15 June 2015

City of West Torrens
165 Sir Donald Bradman Drive
HILTON SA 5033

Thebarton precinct concept/ Holland Street bikeway

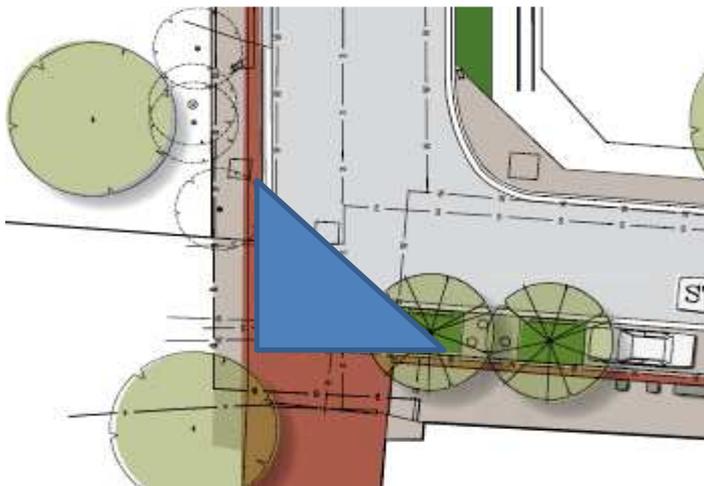
Stirling Street is identified as a shared zone on about p19 of the Concept Planning Report, presenting over-views of the streetscape concept designs for Stirling, Winwood and Holland Streets. However this is later termed 'shared space' where Stirling Street is further detailed (approx. p26). A shared zone has legislated meaning and impact under the Australian Road Rules. A shared space or shared use space is undefined and clarity is sought on which is intended. This becomes even less clear when Winwood Street is identified as a 'shared zone link', with no obvious difference in design philosophy applied to the latter street and, indeed, no justification for such a difference.

While we are supportive of shared zones and shared spaces, the Stirling Street design does not achieve either. It maintains a strong visual demarcation between the carriageway and footpaths/ parking which is at odds with these concepts, and a kerb on the eastern side that is even more at odds with either concept.

We also query a carriageway width that seems wide enough for two cars to pass side-by-side (from the artist's impressions, though the plan and consultation feedback would indicate two-way travel, despite a northbound arrow in the plan view). Without dimensions, it is difficult to see how generous this carriageway width actually is.

We query the provision of the large square 'blocks' adjacent to the on-street car parking, possibly in an attempt to prevent cars from intruding into the footpath. First, at the height shown, these would interfere with car doors opening and would require the width given to car parking to be increased by about 0.6m, leading to a larger vehicular space than would otherwise be required. Second, these effectively reduce the footpath space by their width, reducing the space available to pedestrians. While the eastern footpath appears generous in the artist's impressions, this is much less so the case on the plan – especially with stobie poles retained – and a generous western footpath is desirable. No kerb ramps are shown at the northern end of the eastern footpath and should be provided if a kerb is maintained, or tactile ground surface indicators if a kerb is not provided.
